Project Advisory Committee (PAC) - Meeting #1 Meeting Summary

On March 20, 2017 the City of Hillsboro Parks & Recreation Project Team met with the Project Advisory Committee (PAC) for the Crescent Park Greenway Trail Plan. The PAC was selected to provide perspective and expertise from a broad range of stakeholders, community advisory boards and professional staff. Members were either appointed by their respective agency or through a formal request at board meetings.

PAC Meeting # 1 Summary

Dairy Creek Area 6 - Trail Alignments

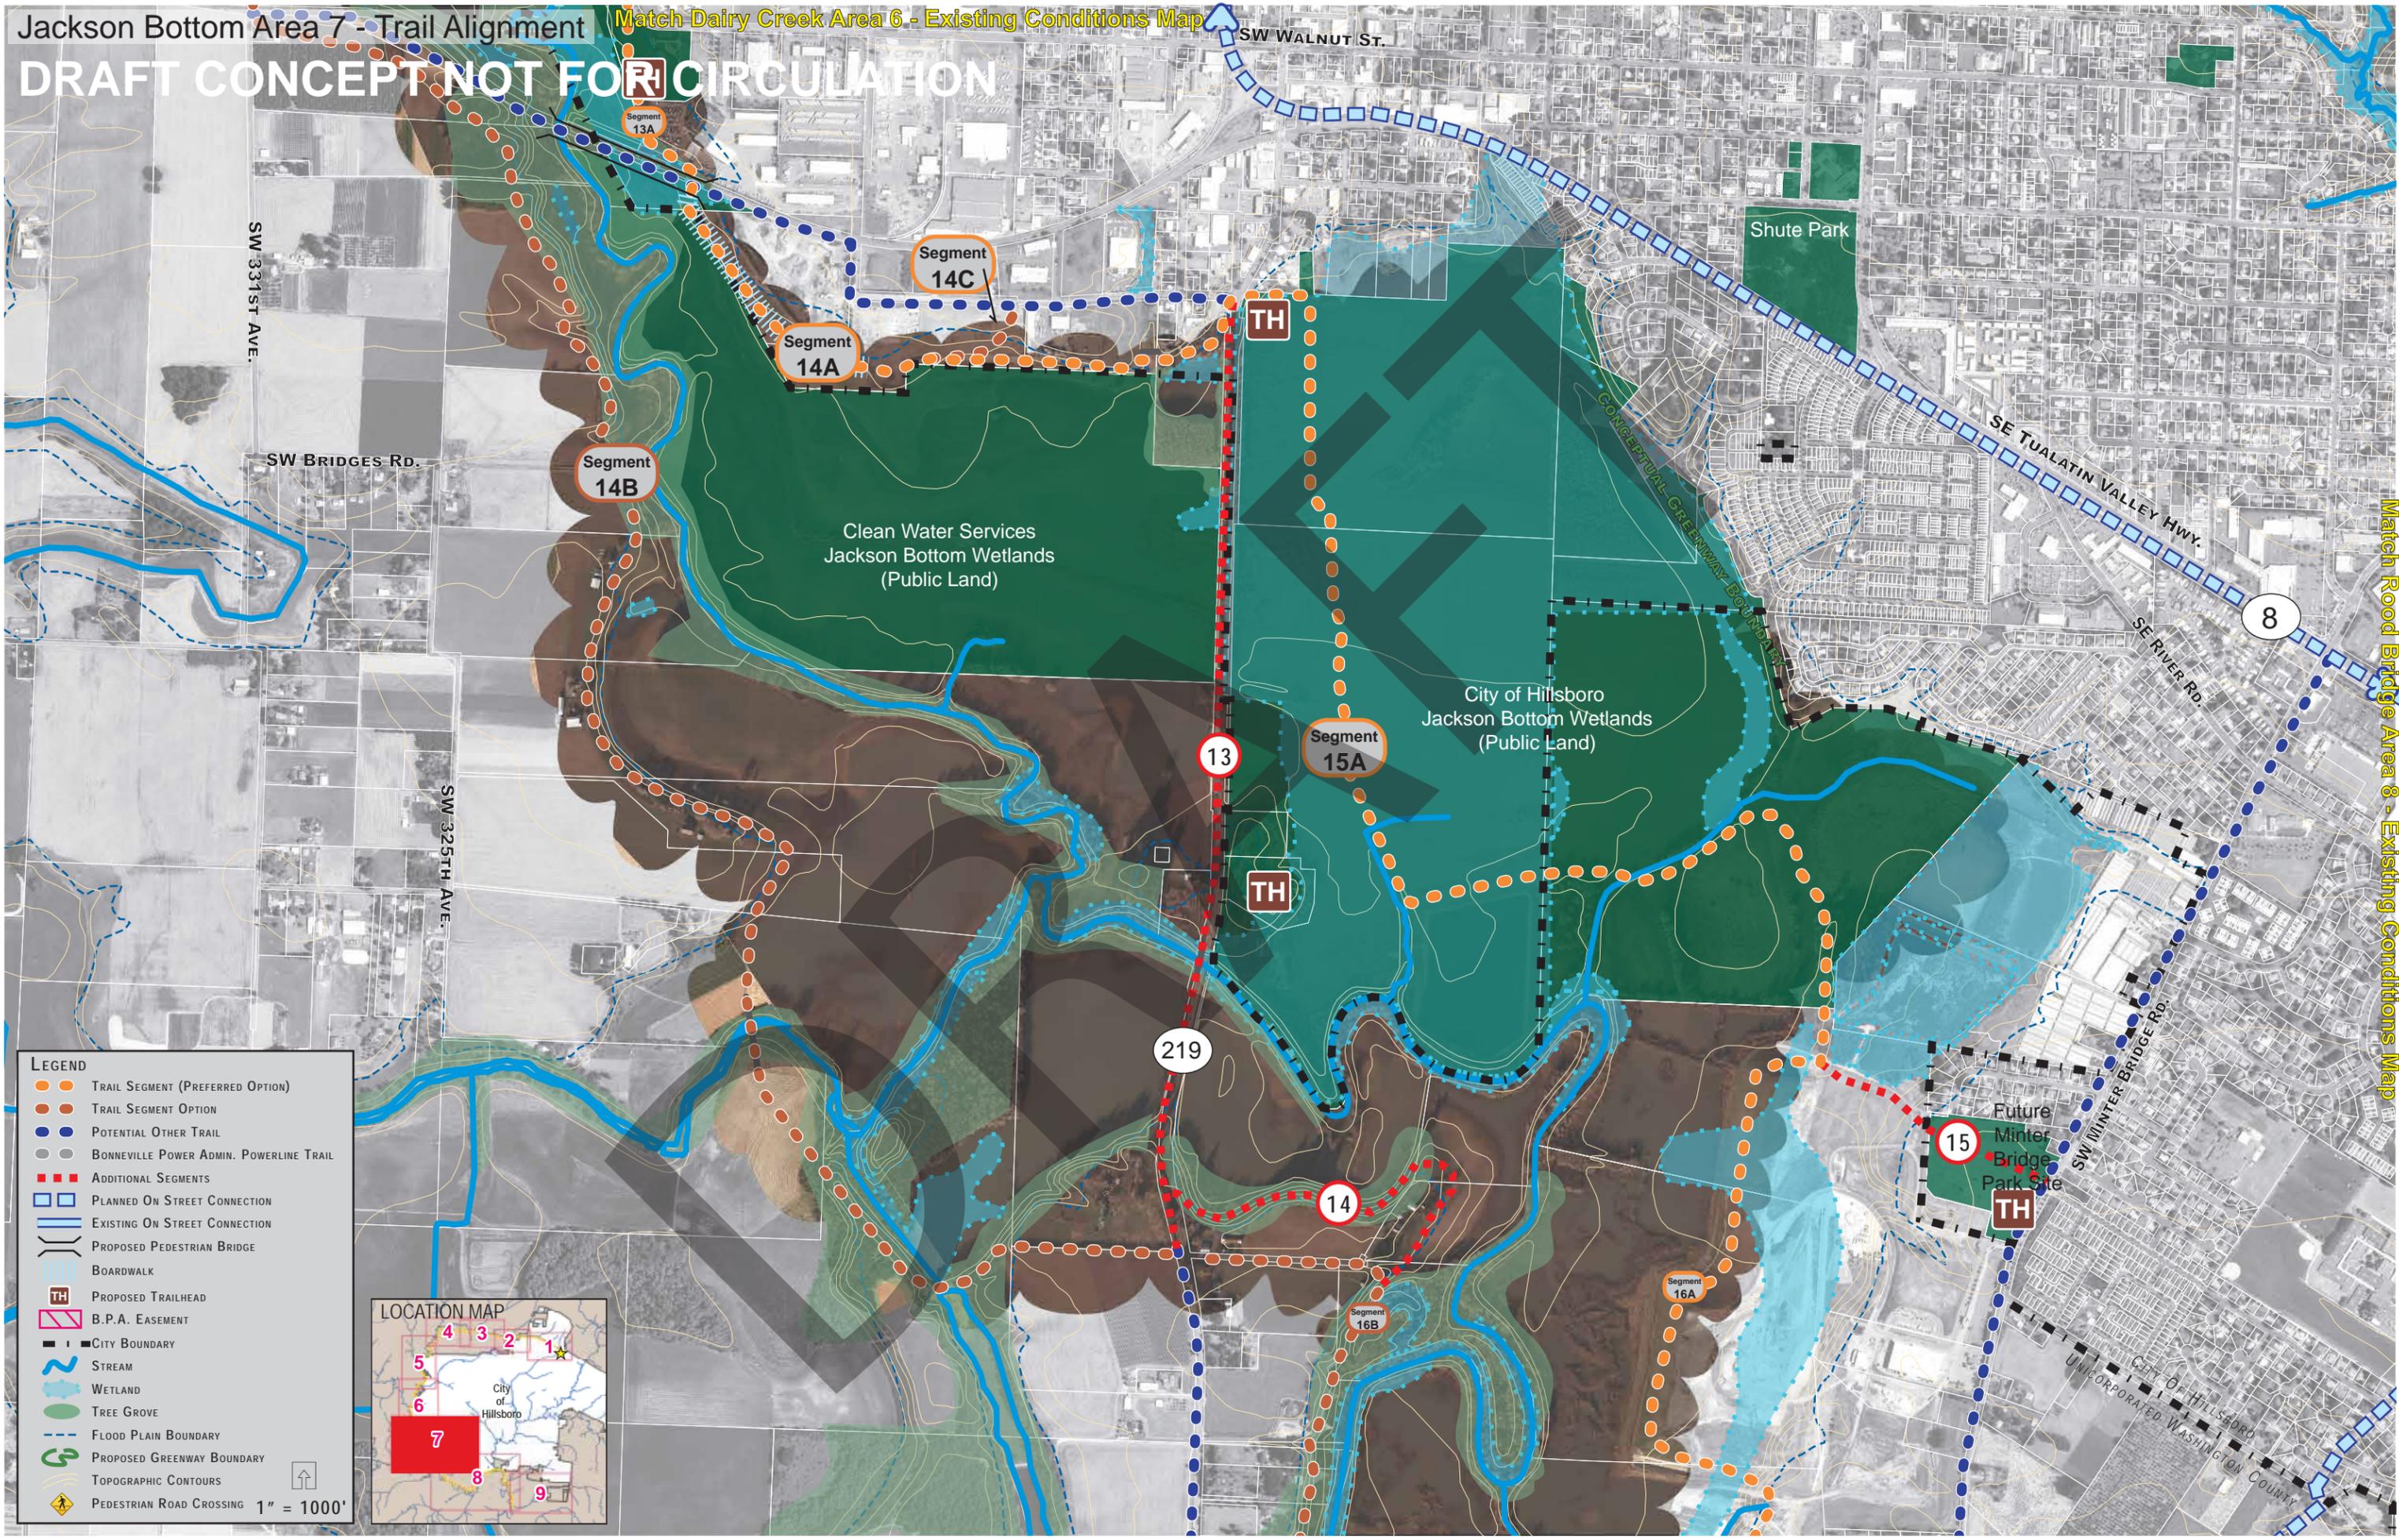
- Preferred option according to the group is east side (segments 11A and 12A possibly 13A depending on Jackson Bottom Preferred Alignment. This option would be easier to implement and provide opportunities for year round use. “B” segments are within the flood plain and are inundated regularly.
- Routing the trail through the cemetery is likely the easiest.
- Fix the “other trail” on east side of greenway that is aligned along the railroad. Move this alignment along Connell Street for a low stress connection (see maps from PAC meeting).

- Change the Main Street trail style on the map to be consistent with other City plans (also on area 7 map).
- Segment 11A (east side of greenway) should be the preferred alignment.
- Make loop connections within this area and that help with loops in Area 5 to the north.
- Research Tualatin Valley Highway on street connection. Make proper adjustments on the map from Washington County TSP.

Rood Bridge Area 8 - Trail Alignments

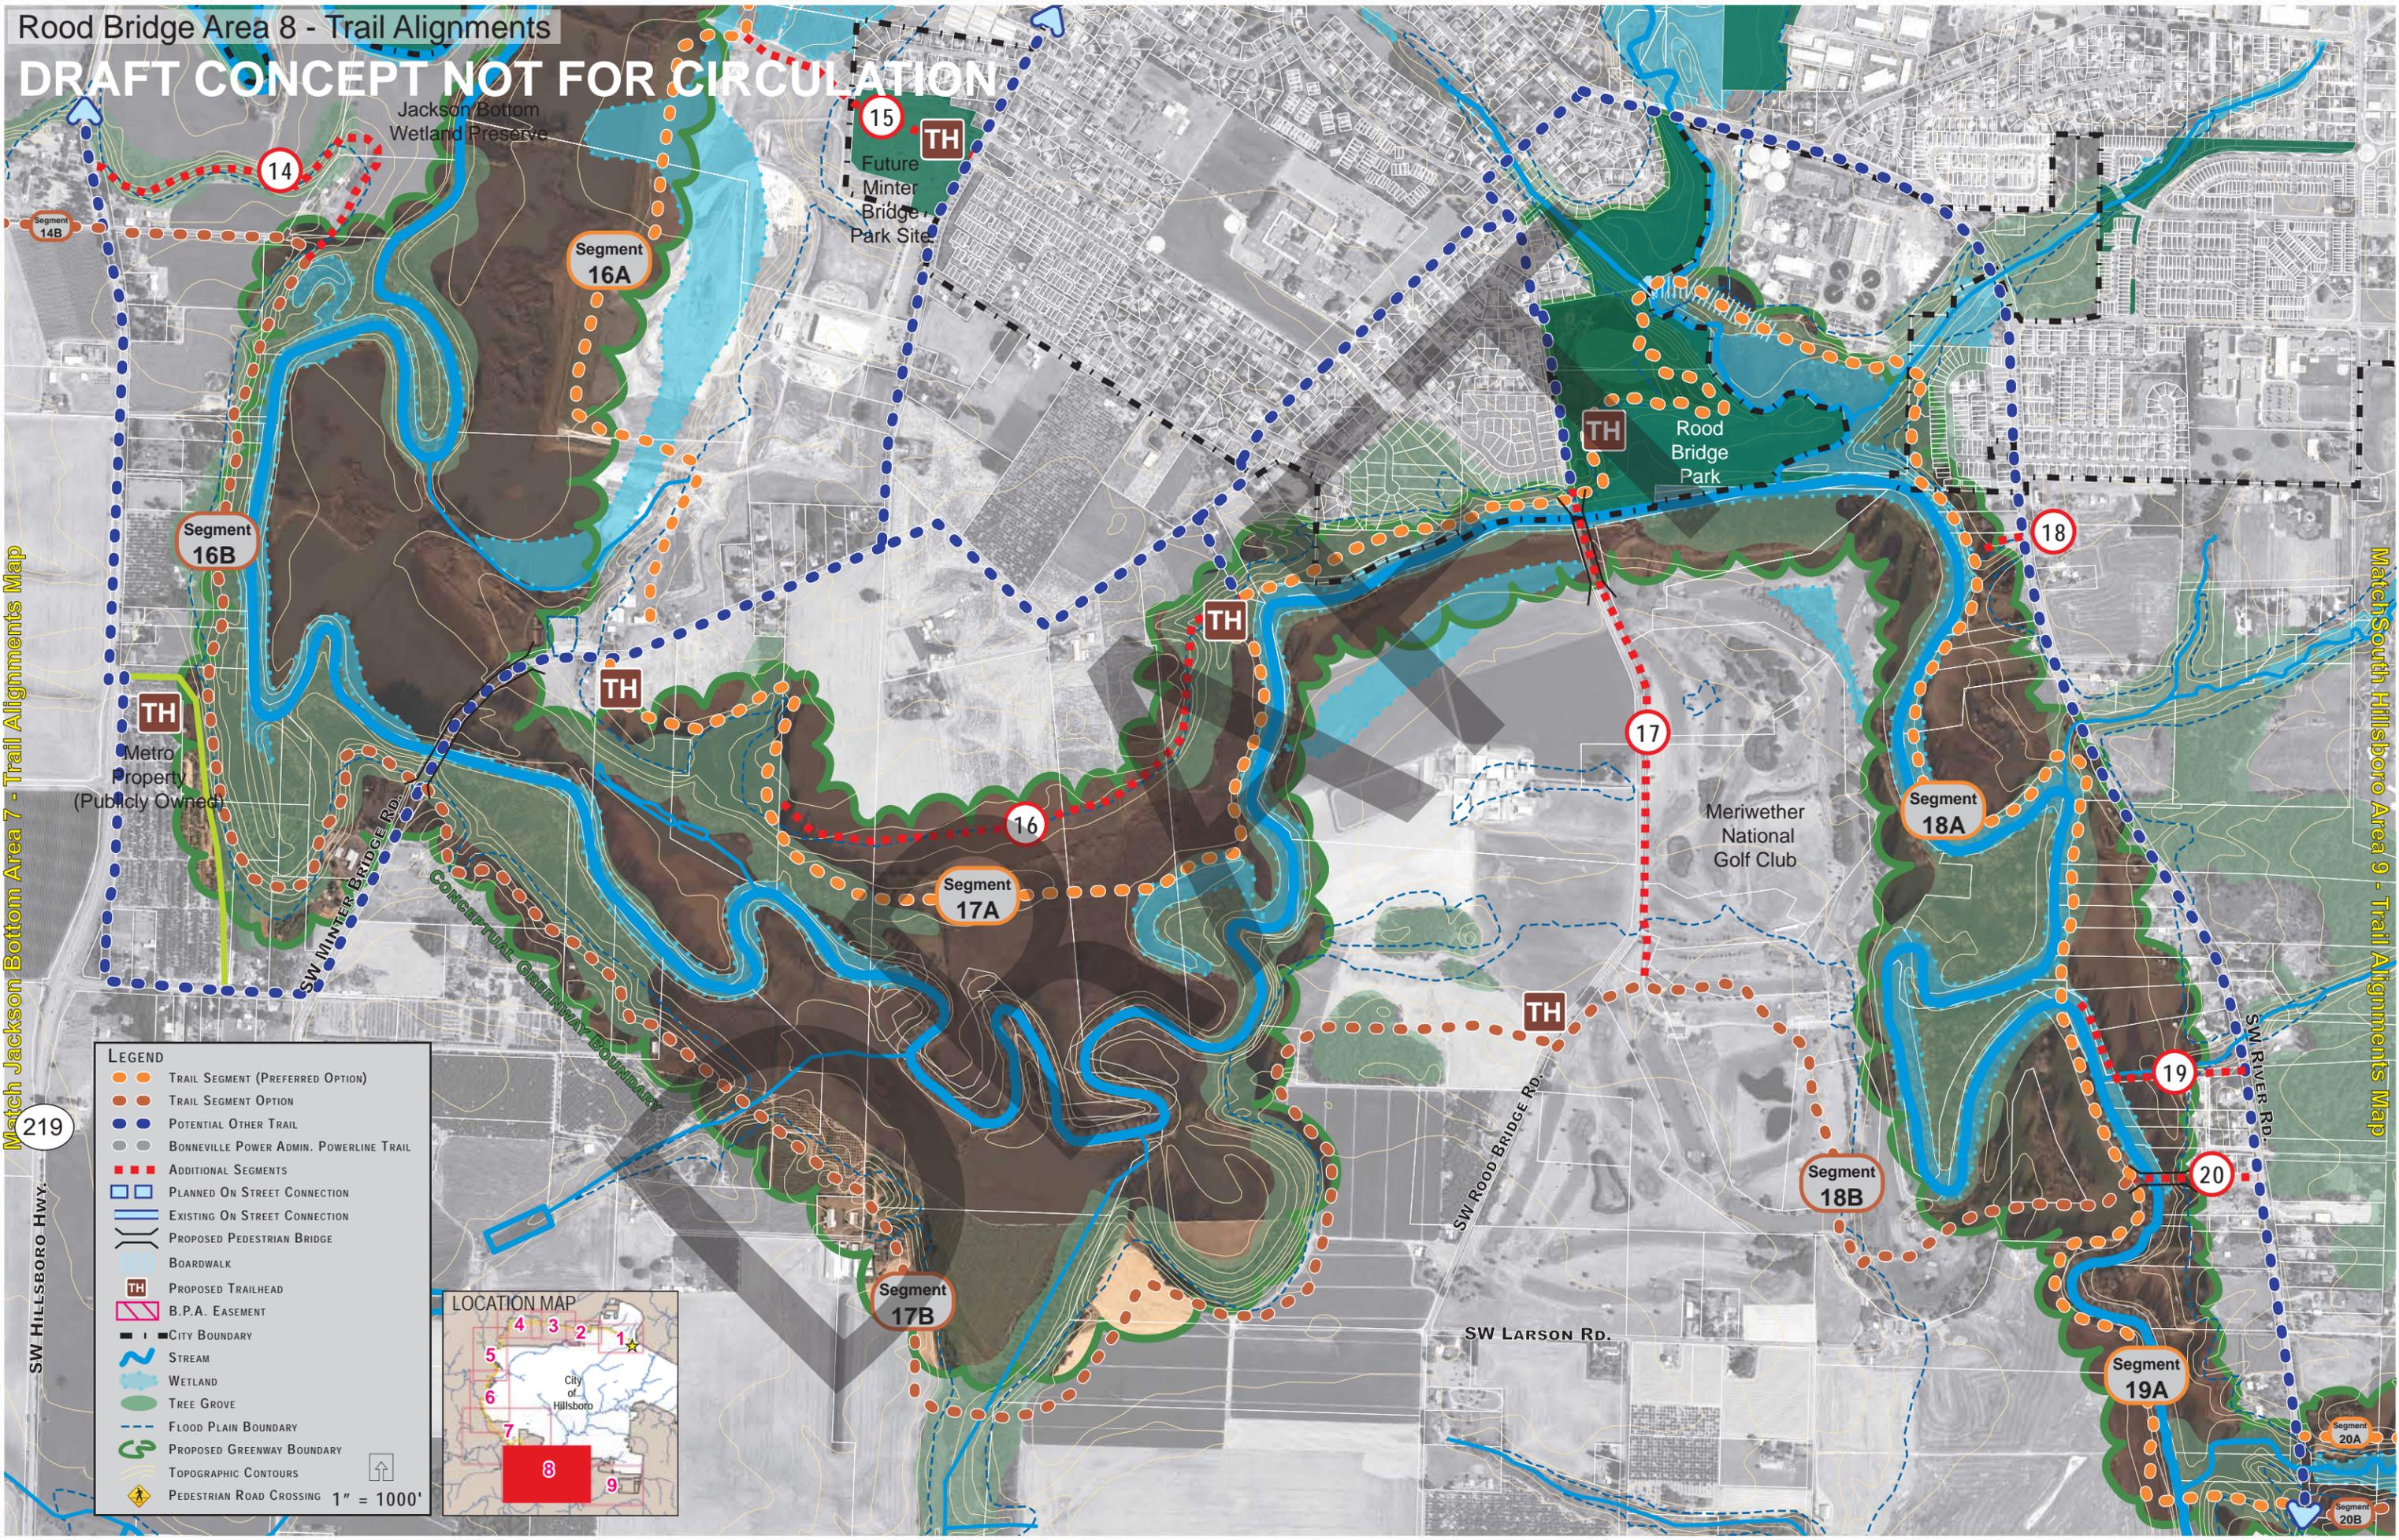
- Pedestrian crossing north of conceptual crossing at Rood Bridge Park is established.
- River Road trail connection was liked and would be important to add to the TSP (both Hillsboro and Washington County (Work with Brad Choi & Dyami Valentine).

- Switch trail segment 17A with segment 16, this will bring option 17A out of the flood plain. With additional segment 16, a nice small loop could be made.

- Discuss the trailhead location at CWS land near Minter Bridge Road in more detail with CWS for the long term. This trailhead may not be feasible, research nearby alternatives.

- Show “other trail” at Morgan Road and Smith Drive through Hillsboro High School as seasonal route. This route needs to be discussed in further detail with Rian Petrick of HSD. This alignment has a good opportunity for its connectivity to the neighborhood and feed into future River Road trail.

- Consider removing segment 16A, long term viability with the landfill is uncertain. For 16A option look to on street network. This could prioritize 17A as the preferred option.
